<b>High Level Review of the Mt Pleasant Operation Mine Optimisation Modification Environmental Assessment May 2017</b>	
<b>Date:</b>	2 July 2018
<b>To:</b>	The President of the Hunter Thoroughbred Breeders Association
<b>From:</b>	Rod Carr, Director at Marsden Jacob Associates

Marsden Jacob Associates, one of Australia's leading independent economic and financial advisory firms, has undertaken an expert review of the economic analysis of the Mt Pleasant Operation Mine Optimisation Modification Environmental Assessment.

Peter Stephenson, Managing Director of Stephenson Environmental Management Australia (SEMA) (CV attached as Appendix C) was requested by the Hunter Thoroughbred Breeders Association (HTBA) to undertake a review and critique of the air quality matters referred to in the assessment of the proposal conducted by the NSW Department of Planning and Environment in the Independent Planning Commission of New South Wales Proceedings No. D512/18 regarding the Mount Pleasant Operation Coal Mine Extension of Mine Life.

## **Review of the Mt Pleasant Operation MOD3 Mine Optimisation Modification**

FIGURE A-5 NSW OEH MUSWELLBROOK AAQMS PM<sub>10</sub> & PM<sub>2.5</sub> DAILY MAXIMA, 2017

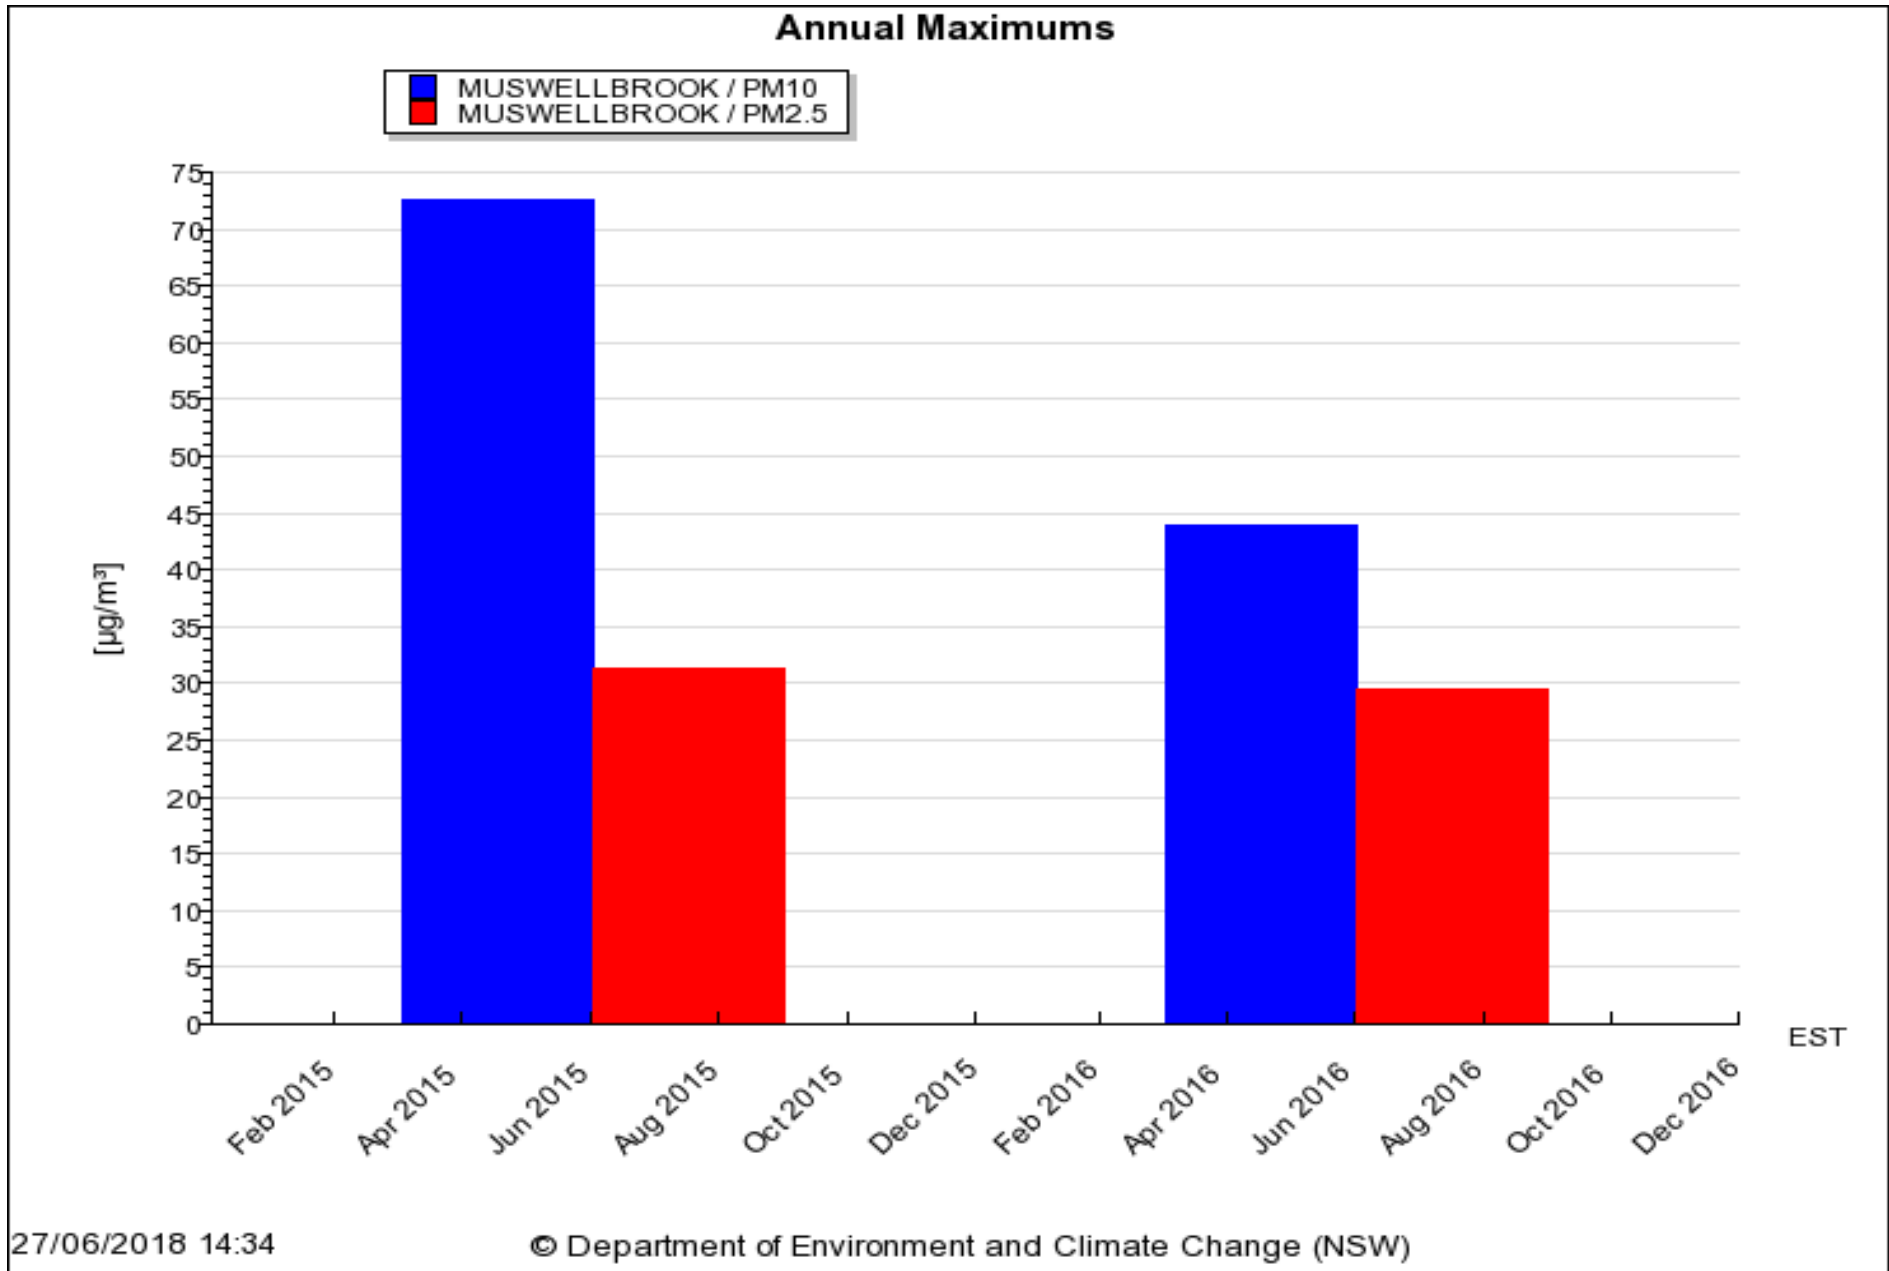
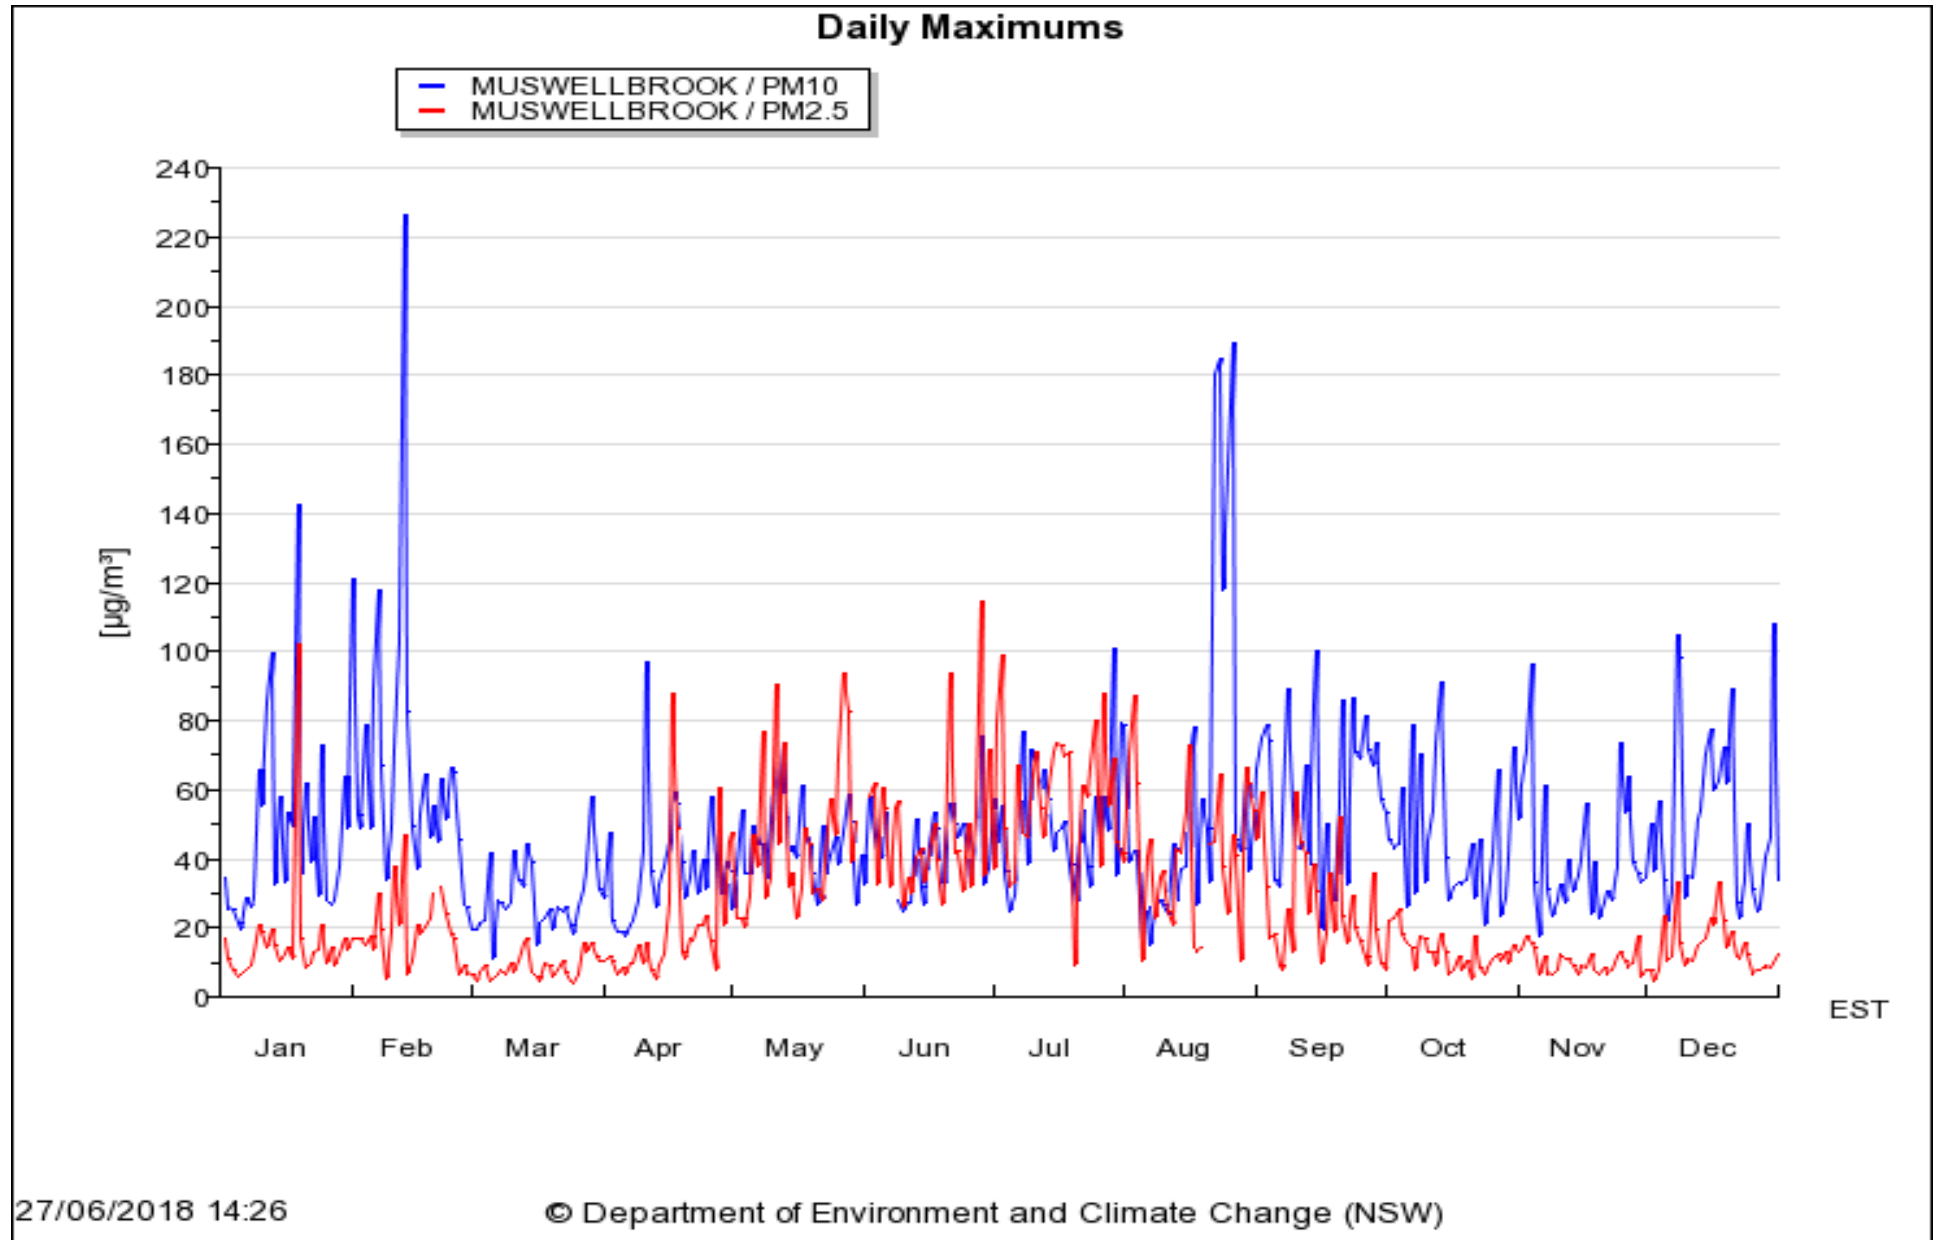
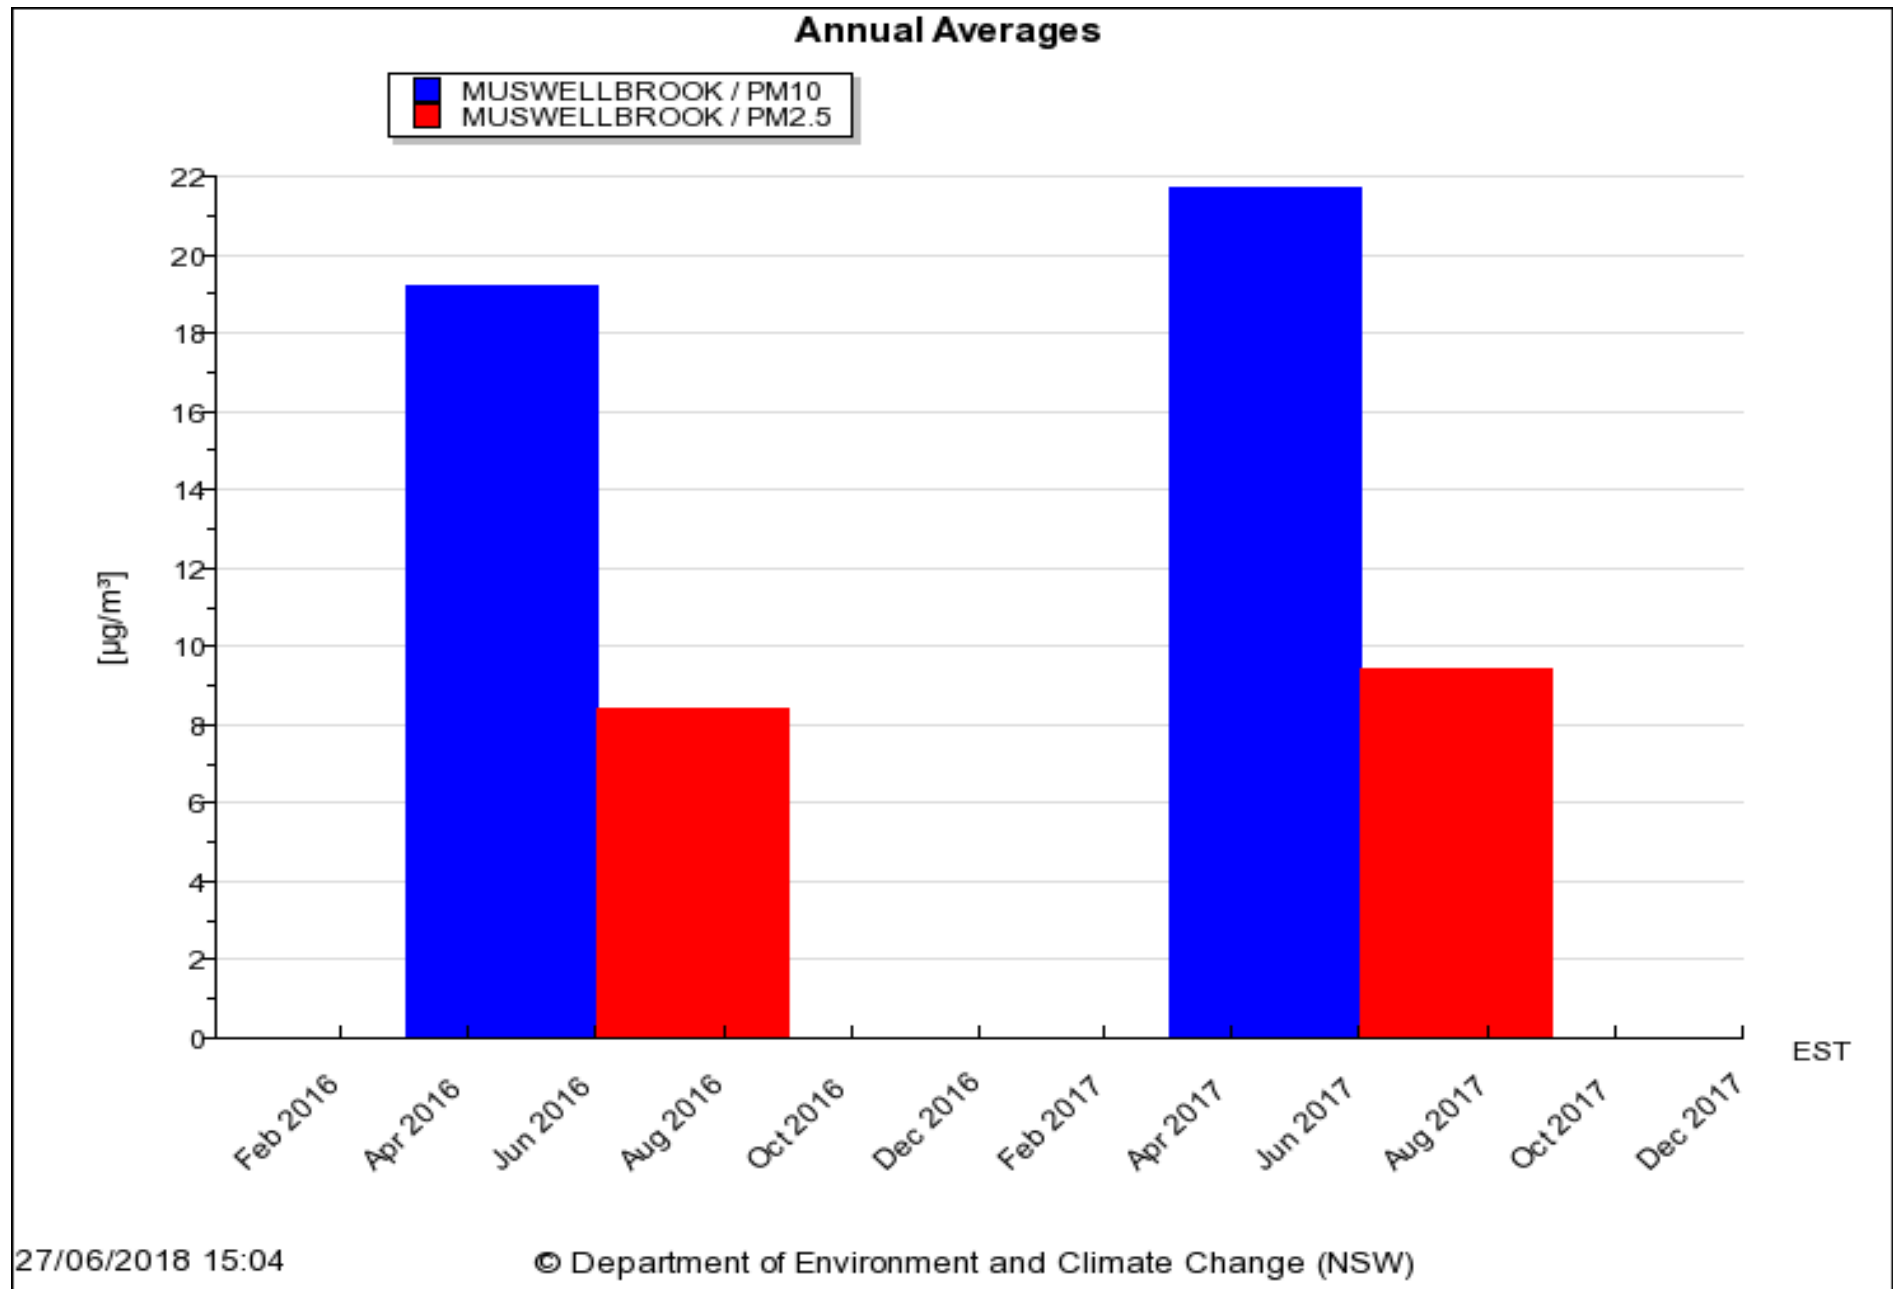
*Furthermore, the plots of data presented in Appendix A of this assessment report show regular exceedances for most of the year. This diminished air quality is the product of previous Planning NSW decisions and further development without radical rework of the mines emission controls will further diminish local air quality.*
